Subject: Pressurized Water Reactor Owners Group
**Responses to the NRC Request for Additional Information (RAI) on
WCAP-16530, "Evaluation of Chemical Effects in Containment Sump
Fluids to Support GSI-191"**

TAC No. MD1119

**Response to NRC Request for Additional Information on
WCAP-16530-NP, Rev. 0, “Evaluation of Post-Accident
Chemical Effects in Containment Sump Fluids to Support
GSI-191”**

Revised Figure 5.2-16: Volume of Precipitate Observed in the Settling Cones

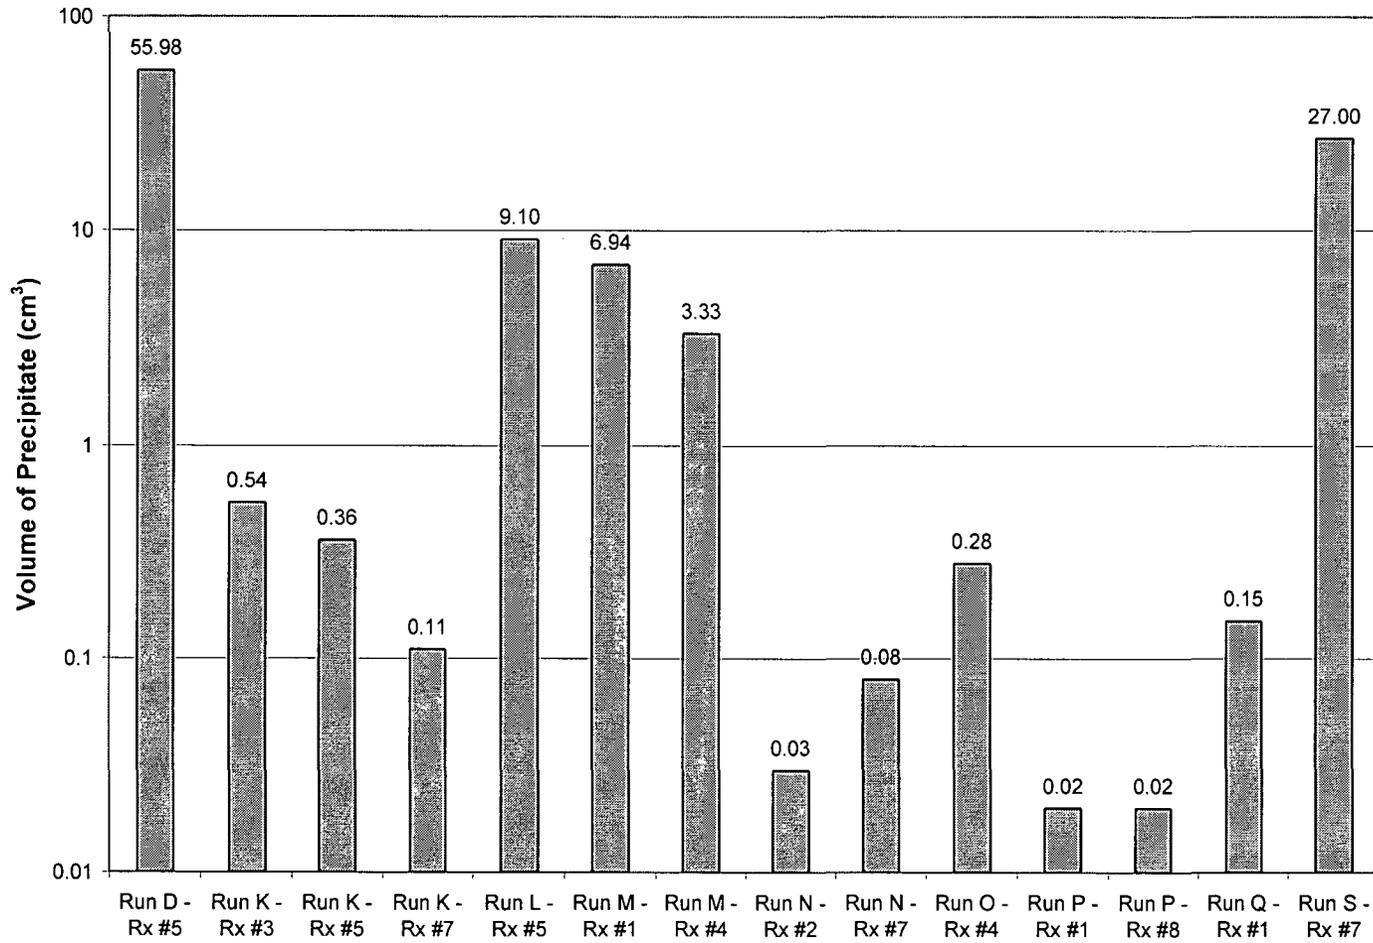
Discussion of precipitate formation on Page 78 states that measurable quantities of precipitates were formed in 25 experiments and the volume of precipitate formed for these cases is shown in Figure 5.2-16. This figure identifies the volume of precipitate observed for 14 run/reaction vessel designations. Later in the discussion, the TR indicates that Table 5.2-4 lists the experiments (13 of 60 experiments) where measurable precipitation occurred. Some of the run/reactor identities in Figure 5.2-16 (e.g., P1, P8, Q1) do not match with the identities in Table 5.2-4 (e.g., K2, K4, N2). Please clarify the discrepancy in the

number of experiments with measurable precipitation and test run identifications between Table 5.2-4 and Figure 5.2-16. For all experiments with measurable precipitate, please provide a table showing:

The discussion refers to 25 experiments in which precipitates formed which is a larger number than in Figure 5.2-16 or Table 5.2-4. The 25 value included runs that were rejected for experimental difficulties. The correct value is 17.

A corrected Figure 5.2-16 is shown below. The original figure included Run M7, a bad run, which has been eliminated. Run N2 was mislabeled as N5, which has also been corrected. The original figure also included only precipitates that formed by cooling from 265 °F. Four runs have been added (D5, P1, P8, and Q1) where precipitates formed upon cooling from 190 °F, even though these runs were not included in the precipitation test matrix. This figure does not include the 3 precipitates that formed by mixing different solutions, since different volumes of solution were involved than for the cooling tests.
